Access Compliance Report Public Rights-of-Way (Curb Ramps)

Intersection ID: 22211 Main Street: SHARON_VIEW_RD Cross Street: VAUXHALL_CT Location: N

ADA ID: C85E57ACDF22 Ramp Type: Combination2Diag Initial Pass/Fail: Fail Overall Compliance: No Severity Score: 0

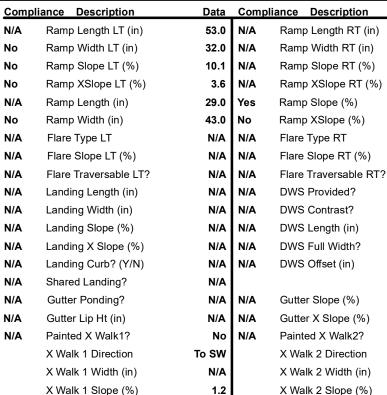
Not Found, R304.5.1, R304.5.1, R304.5.3, R304.3.2

Remove & Replace Curb Ramp With Two New Directional Ramps or Equivalent.
